EN 46001

**SUBJECT: NRC INSPECTION REPORT NO. 70-27/2010-003 AND NOTICE OF VIOLATION**

Report No.: 70-27/2010-003

**Figure 1 – High-Level Dissolver Enclosure Top View**

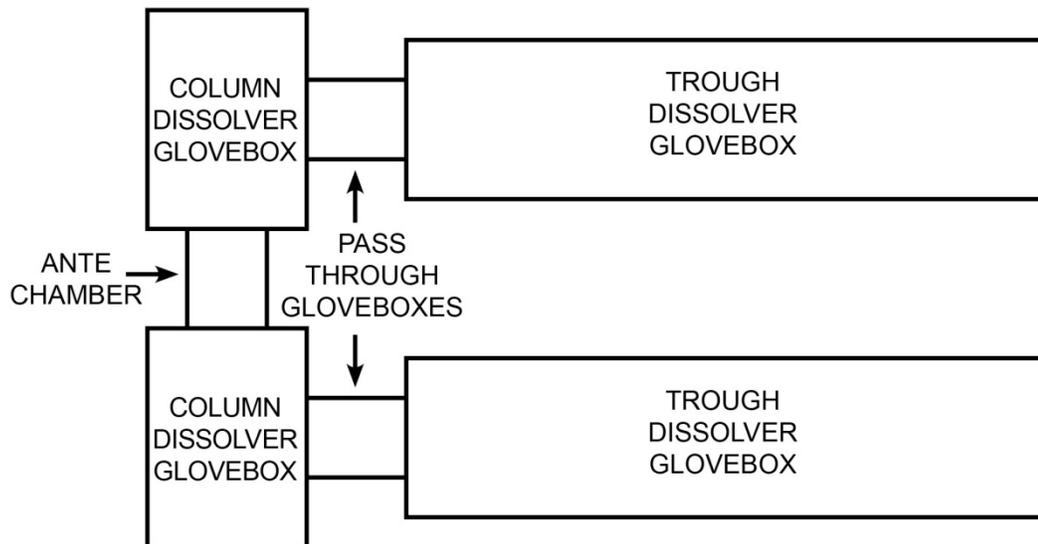
Following glovebox flushing operations on June 11, 2010, UR area operators observed approximately one-liter of solution at the bottom of one of the pass-through gloveboxes in the high-level dissolver enclosure. The concentration of the solution was determined to be 26 grams U-235/liter. After the event the licensee cleaned both pass-through gloveboxes to remove any residual material that was in the pass-through gloveboxes. The licensee measurements indicated that a total of 111.65 grams of solid U-235 was

removed. The licensee determined that presence of fissile solution in the pass-through glovebox represented an unanalyzed condition that failed to meet the performance requirements of 10 CFR 70.61 for NCS.

Following clean out of the residual material in the pass-through gloveboxes, the licensee shut down the system and initiated a corrective action (CA201001322) to investigate the event. The investigation determined that fumes from dissolution of uranium in the trough dissolver entered the pass-through glovebox over time and adhered to the inner walls. Also, aqueous solution entered the pass-through glovebox from the trough dissolver through the hatchway during trough dissolver cleaning operations between dissolution batches when the water hose is directed at the hatchway. This resulted in fissile solution in the bottom of the pass-through glovebox where it was difficult to see due to the enclosure configuration and lighting. The licensee investigation did not identify fume penetration into the ventilation system.

The inspectors reviewed the criticality safety analysis for the process and interviewed the responsible criticality engineer. The original analysis for the process did not anticipate or analyze for the presence of solution or material being left in the pass-through glovebox. The inspectors determined that the 26 grams U-235/liter solution that was found in the pass-through glovebox was below the license limit of 573 grams of U-235 for a fully reflective system ( $k$ -effective = 0.95). The solution was more than a minor safety concern because the licensee had failed to analyze the accident sequence and therefore the licensee had failed to establish IROFS to prevent a nuclear criticality accident in the pass-through glovebox.

License Application Section 5.1.1 states, in part, that the licensee is committed to conducting NCS evaluations to assure that under normal and credible abnormal conditions, all nuclear processes will remain subcritical and maintain an approved margin of subcriticality for safety. Under Section 5.1.1, the licensee is also committed to establishing and maintaining NCS IROFS, based on current NCS evaluations. The failure to conduct an NCS evaluation and establish and maintain NCS IROFS against the accumulation of fissile solution in the unsafe geometry pass-through glovebox is Violation (VIO) 70-27/2010-003-02.
